SCH No. 2014091020

**TESORO
LOS ANGELES REFINERY
INTEGRATION AND COMPLIANCE PROJECT
FINAL
ENVIRONMENTAL IMPACT REPORT**

VOLUME VIII: Appendix G (Comment Letter No. G1-98 – Appendix G2)

Figure 106.28-1
Historical Flaring Emissions for the Wilmington Operations
(2007 – 2015)

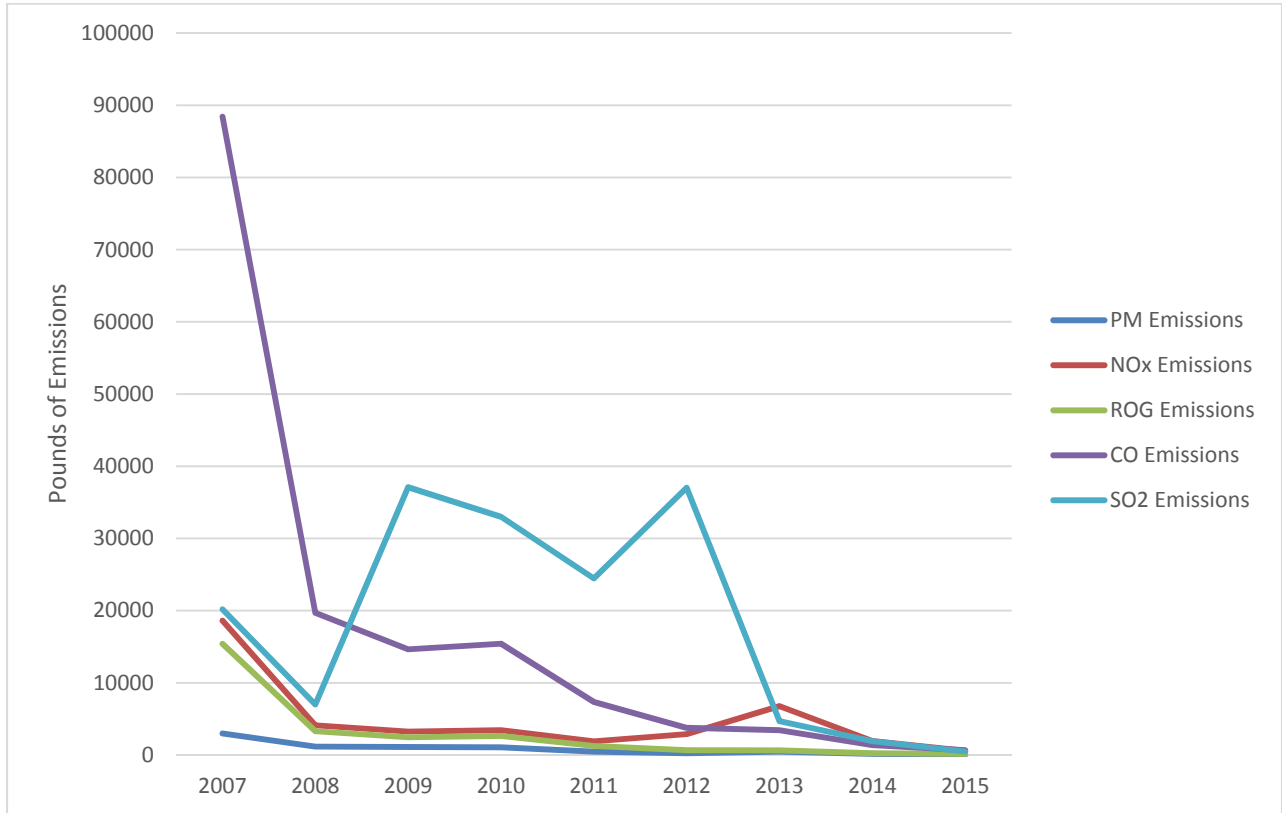
The comment appears to list a selected history of Wilmington Operations emissions and compliance data by comparing to SCAQMD's Facility Information Detail (FIND) database. The majority of the data incorrectly calculates the percentage difference (i.e., the percent difference is the (end value – start value)/start value*100, not end value/start value*100 as presented, which overstates the result by 100 percent). The comparison of historic data is not relevant to future activities because the conditions that generated the historic data may not be representative of future trends. Additionally, SCAQMD has been more prescriptive in emission calculation methodologies and more inclusive of sources over time. As explained in Section 4.1.2 of the DEIR, Refinery operations vary, which results in fluctuating emissions levels as depicted in the data presented in the comment. According to Tesoro, for the years under Tesoro ownership, the variability in yearly emissions is primarily attributed to operational variability such as unit turnarounds (unit shutdowns for maintenance). The SCAQMD rules and regulations are designed to control emissions and achieve air quality goals, while the SCAQMD CEQA significance thresholds apply to project-specific impacts. The operational emissions of the proposed project were determined to be less than significant (see DEIR Table 4.2-4).

With respect to the flare emissions data, the comment provides no basis for the analysis. Figure 106.28-1 presents the reported flare emissions for the Wilmington Operations from 2007 through 2015. The data do not corroborate the unsupported statements made in the comment regarding flaring. See also Master Response 15 and Response G1-78.207 that explains the variability of flaring and the restrictions imposed by SCAQMD Rule 1118.
